**PJM INTERCONNECTION, LLC  
TRANSMISSION EXPANSION ADVISORY COMMITTEE**

**RE: ARTIFICIAL ISLAND OPEN WINDOW SUBMISSION PROCESS**

**PUBLIC SERVICE ELECTRIC AND GAS COMPANY'S  
POST-TECHNICAL CONFERENCE COMMENTS**

Image 6. Desktop Forested Wetlands Assessment

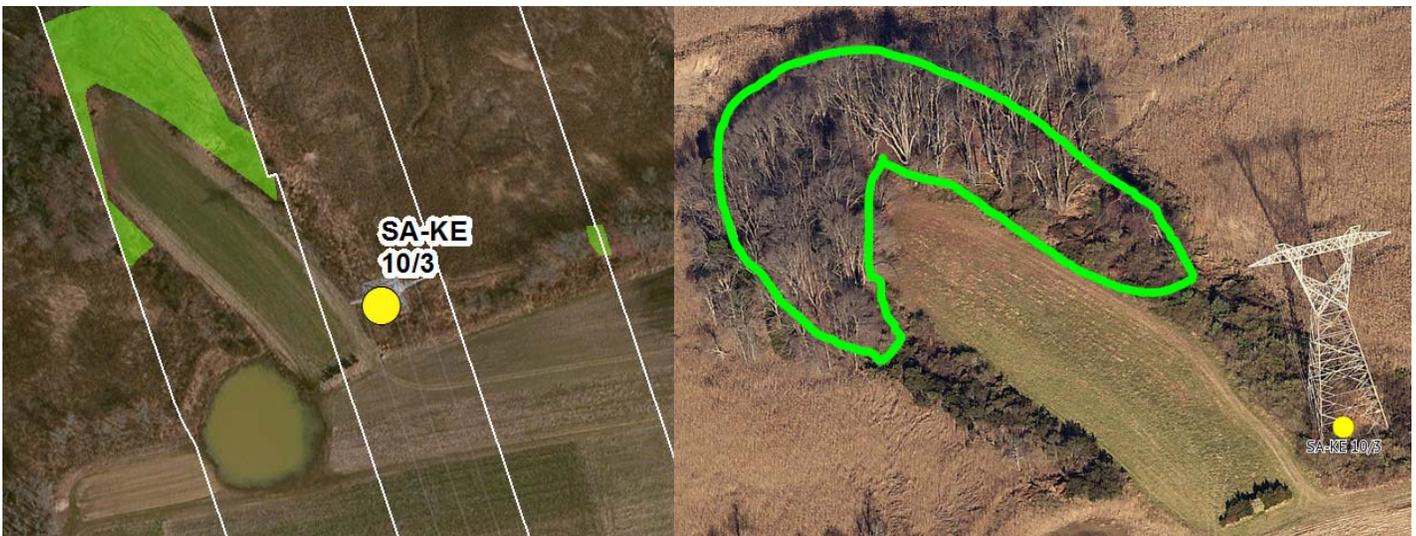
- Forested Wetlands Impact is much less than previously documented.
- Recent Oblique Aerial Imagery and State wetlands datasets confirm analysis

ROW would have a large impact (approximately 320 acres) of deciduous wooded wetlands in New Jersey (as noted in the GAI report). PSE&G counters that this is not the case. Available state mapped wetlands were reviewed and were compared with November/December of 2013 oblique aerials showing tree cover. The following table is the summation of potential wetlands impacts for the proposed ROW expansion:

In areas of the proposed ROW expansion where the state data had mapped deciduous wooded wetlands, PSE&G performed a desktop analysis to confirm impacts. This is shown in Image 6 below.
